| Safety Recall Campaign | 2011-2015MY Optima (TF) |
| SC284TF (Rev 1, 5/31/2024) | May 2024 |

HECU MULTI FUSE REPLACEMENT (SC284TF)

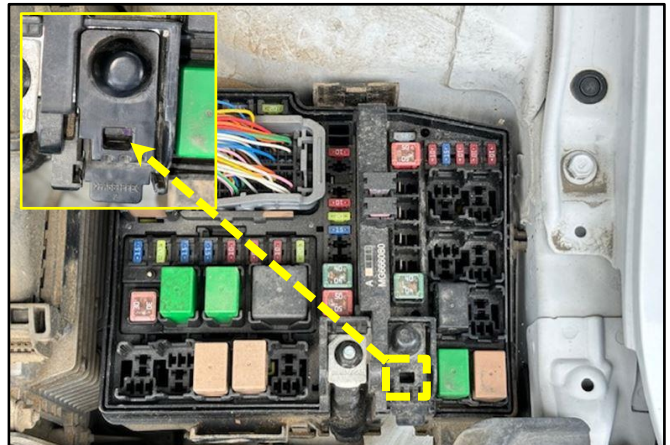
3. Remove and discard the junction box fuse cover.

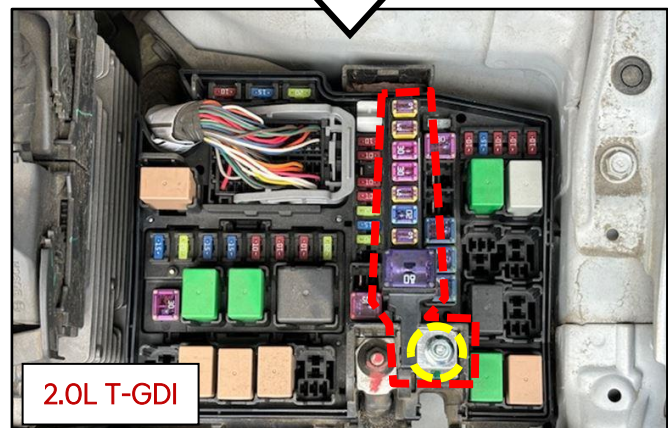
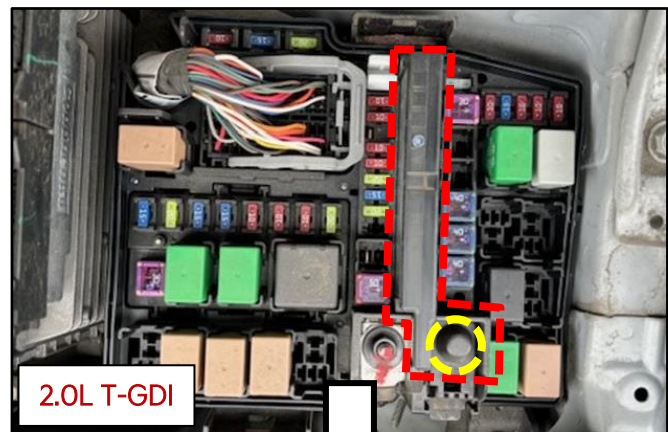
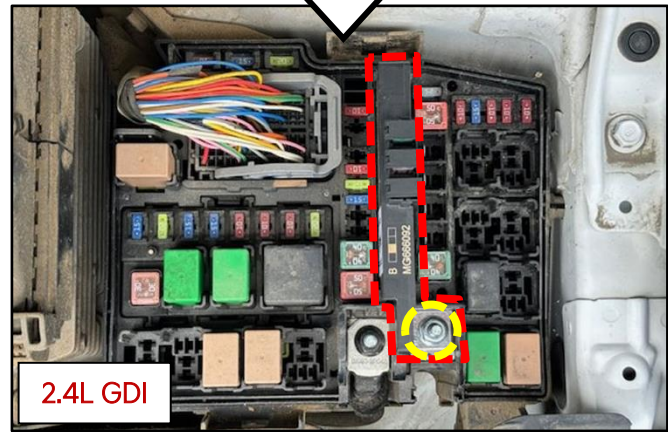
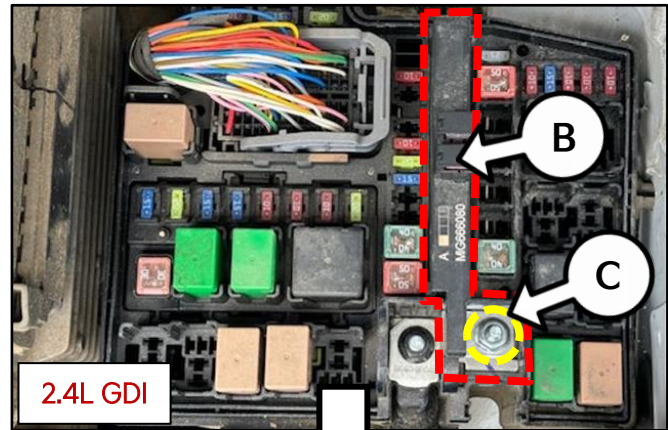
- 5a. Locate the Multi Fuse (B) for ABS1 and loosen the 10mm Multi Fuse retaining nut (C) and remove the Multi Fuse.
- 5b. Install the **new** Multi Fuse (B) and tighten the retaining nut (C).

Note: The Multi Fuse designs differ between 2.4L GDI and 2.0L T-GDI vehicles.

Note: Drill a hole through the center of the removed Multi Fuse. DO NOT reuse.

Tightening torque for retaining nut (B):
7.2 - 8.7 lb.ft (9.8 - 11.8 N.m)

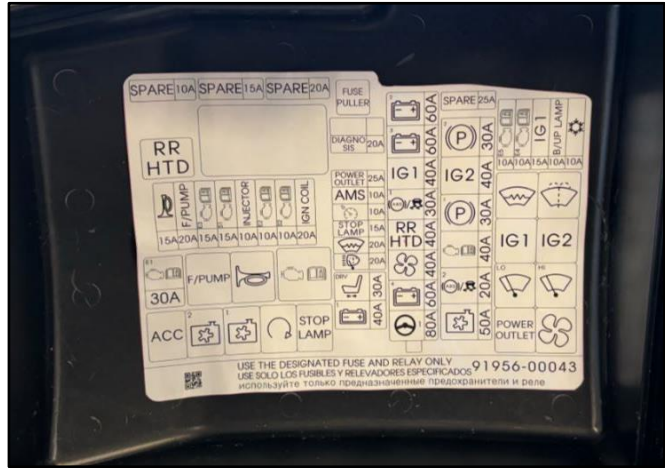
- 6. Adhere the new fuse label to the bottom of the new junction box fuse cover, as shown.
